SERVICE INFORMATION LETTER

Subj: Notice of Escape for 9018708-2 AC Power Outlet Assembly
Reference: NOE9018708-2-01
Date: April 10, 2025

This Service Information Letter (SIL) is applicable to the Universal AC Power Outlet (part number 9018708-2) with FAA-PMA approval for installation into aircraft. This part number is manufactured by Mid-Continent Instrument Co., Inc. (dba True Blue Power and Mid-Continent Instruments and Avionics).

Table 1	
Mate-N-Lock Pin	Receptacle Terminal
1	Line (L)
2	Neutral (N)
3	Ground (G)

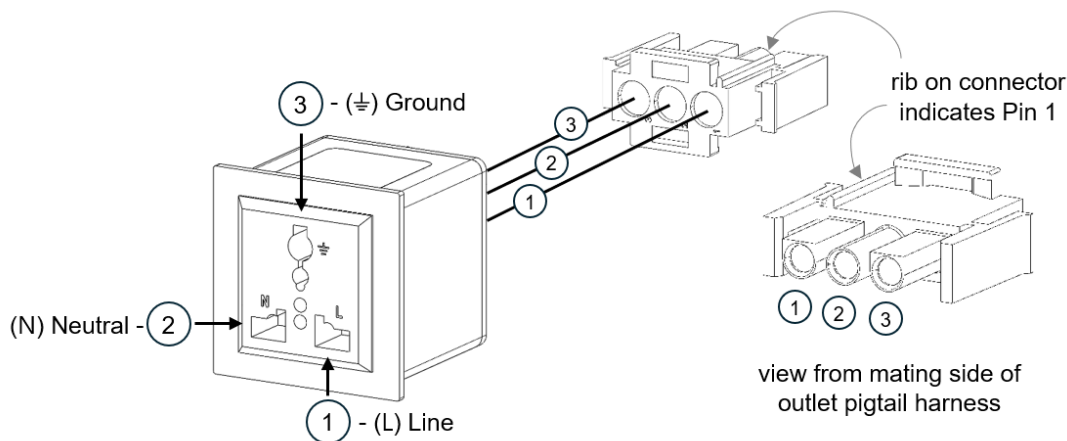
Some portion of 9018708-2 outlets manufactured during the applicable date range may have been assembled with the Line and Ground wires switched between the outlet and the integrated cable harness connector.

1. For an Outlet NOT installed:
 - a. Using an electrical meter, check for continuity between the terminals and the pins of the wire harness connector per Table 1
2. For an Outlet installed in aircraft:
 - a. Apply power to the outlet, and using an electrical meter, check for appropriate voltage between the Line (L) receptacle terminals of the outlet and the Neutral (N) receptacle terminal, as shown in the figure below. Typical alternating current (AC) voltage should be either 100-120VAC or 220-240VAC.
